REPORT OF THE CHIEF OFFICER PLANNING AND REGULATORY – 7th OCTOBER 2019

APPLICATION NO:
P/2019 /0578

LOCATION:
WATERSIDE BARN NEWBRIDGE
ROAD NEWBRIDGE WREXHAM LL14
3JE

DESCRIPTION:
REAR EXTENSION TO INCREASE
SIZE OF KITCHEN / DINING ROOM

Figure 4. Existing Side Elevation Figure 5. Proposed Side Elevation

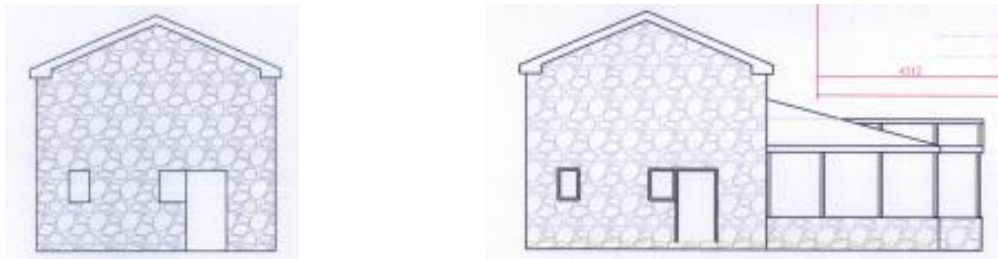
Design: The extension is considered to be inappropriate in terms of its scale, design and layout because of the impact it would have upon the character and appearance of both the existing building and surrounding locality (see existing and proposed elevations below at figures 2, 3 and 4). The extension would produce an overly dominant feature, visible from public viewpoints, to the detriment of the visual amenities of the area and original form of the barn which currently retains its simple L-shaped plan.

In considering the proposals, reference is made to LPGN 3: Converting Rural Buildings. This states that 'there is a presumption against large extensions to the building.' The extension proposed extends to 4m from the building, reaching just over 4.3 metres at its widest point and extends across almost half the length of the elevation, obscuring much of the ground floor stonework. The scale of the extension is therefore considered to be much too large. Extensions are normally only considered appropriate to former agricultural buildings where they maintain the simple, traditional character and form of the building. The form of the proposed extension is over complicated by the central projection which creates an overly domestic feel and no information has been submitted with regards to the proposed materials.

LPGN 3, 13 and 20 provide general guidance to which this development would conflict. Specifically, LPG 20 states (at page 4) that front extensions should not project a significant amount from the front wall of the existing dwelling and should be simple in design and respectful of the original lines of the building. The proposed extension does not accord with this guidance as the projection competes with the width of the gable end of the building emphasising its disproportionality contrary to the guidance set out in LPGN 3 and 13 (at pages 2 and 4 respectively) that extraneous features of inappropriate scale, such as this, that adversely affects the building should be avoided. This is further compounded by the extent of the glazing across the entire frontage which is not reflective of the current building.

I have requested that the central projecting element be deleted and that the projection of the extension reduced to 3.3 metres (which will allow for an internal floor area of 3 metres). I have also requested that the extent of the

glazing is reduced and better detailed to match the existing, and for submission of the proposed materials. This would result in a more modest addition, better proportioned to the existing building and of appropriate detail. The Applicants have confirmed that they are unwilling to make any amendments to the proposed scheme and I am therefore unable to support this application.
